WHEREAS, on October 9, 2006, by Roll Call No. 06-1975, it was duly resolved by the City Council, that the City Council consider a proposal from Jake Christiansen, as Manager of Nelson Development 14, L.L.C., to rezone certain property owned by the company and located in the vicinity of 401 31st Street from the "R1-80" One-Family Residential District classification to the "PUD" Planned Unit Development District classification, and to approve a "PUD" Conceptual Plan for the development of the property with four single family dwellings, and that such proposal be set down for hearing on October 23, 2006, at 5:00 P.M., in the Council Chambers at City Hall; and,

APPROVAL of a request from Nelson Development 14, LLC (developer) represented by Jake Christiansen (officer), to rezone property located at 401 31st Street from "R1-80" One Family Residential District to "PUD" Planned Unit Development and to approve a proposed "PUD" conceptual plan for the development of the property with four single-family dwellings, subject to the following modifications: (ZON2006-00129)

PRELIMINARY CONCEPTUAL PLAN FOR SOUTH OF GRAND ESTATES
 A PLANNED UNIT DEVELOPMENT IN THE CITY OF DES MOINES, COUNTY OF POL

PRELIMINARY CONCEPTUAL PLAN FOR SOUTH OF GRAND ESTATES
A PLANNED UNIT DEVELOPMENT IN THE CITY OF DES MOINES, COUNTY OF POLK, STATE OF IOWA
SHEET 2 OF 3

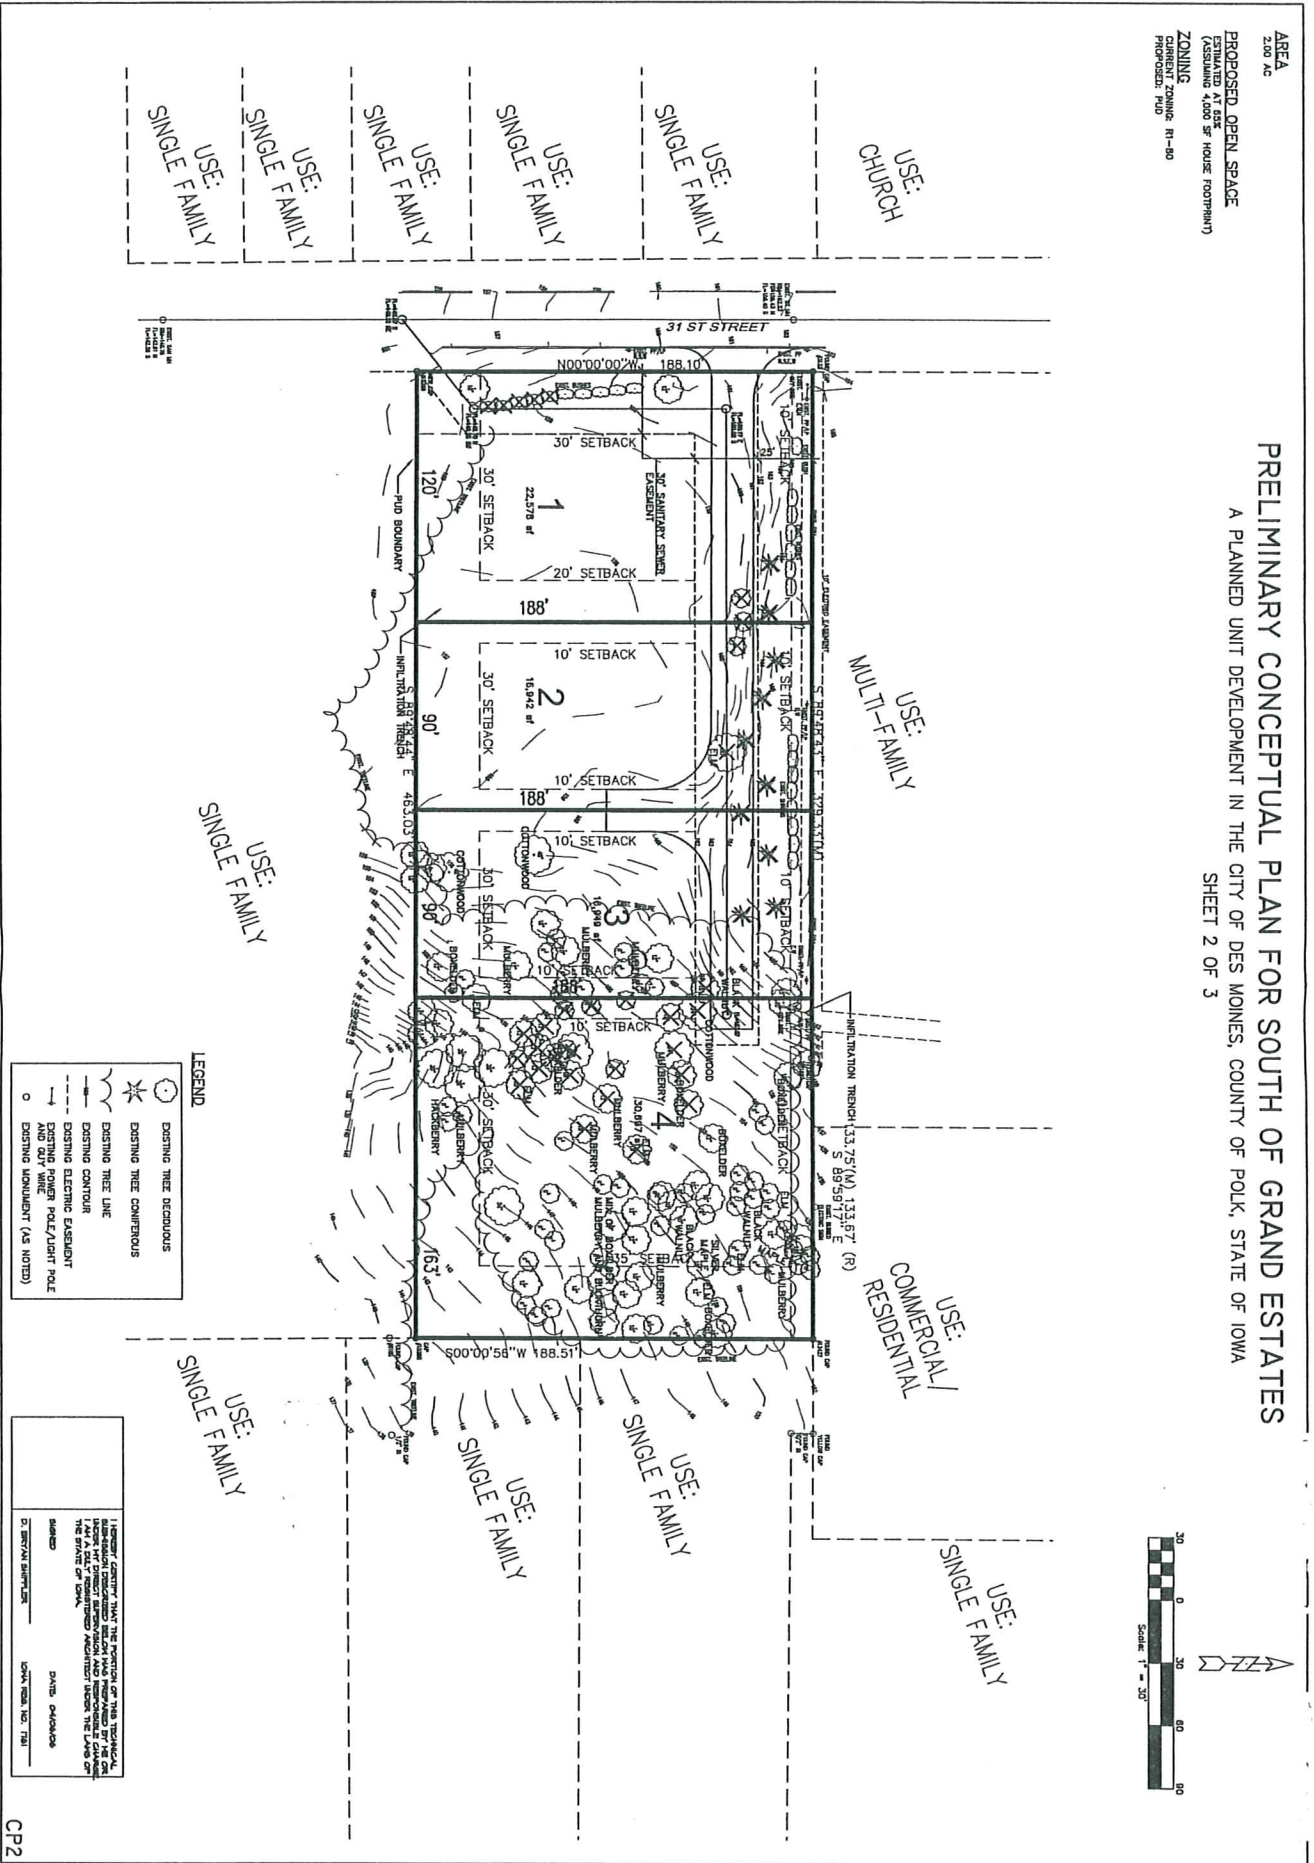
Part C) Staff recommends approval of the submitted PUD Conceptual Plan subject to the following modifications:

1. Provision for permanent conservation easements on the eastern and southern portions of parcel 4, and on the southern portion of parcel 3 to guarantee future protection of those timbered areas after single-family development occurs.
2. Provision of a statement that a tree protection and mitigation plan will be provided with any development plan/preliminary subdivision plat or grading plan as follows:

- J) No building construction shall be allowed in the reserve are.
3. Revising the storm water statement to read that storm water run-off from between the pre-developed 2-year and 100-year storm frequency will be detained on site in addition to the implementation of the stated conservation methods. Also, indicating that off-site water will be picked up and conveyed to an appropriate outlet to be released at velocities that are non-erosive.

4. Provision of proposed grading contours.
 5. Replacement of the removed evergreen plantings on a one for basis in a location north of the private drive. Replacement of the shrub line indicated for removal by the sanitary sewer installation.

6. Addition of Conceptual street tree plantings in the parkway of 31st Street at one per 40 lineal feet
 7. Provision of a note that fire lanes and turnarounds shall be prominently signed for no parking.

8. Provision of a statement that any single-family home will have a minimum square footage above the basement level and independent of the garage of 1,200 square feet for a single-story and 1,400 square feet for a two-story or greater.

9. Provision of a statement that homes on parcels 2,3, & 4 must have a primary entrance oriented toward the private drive, and the home on parcel 1, must have a primary entrance oriented toward either 31st Street or the private drive.
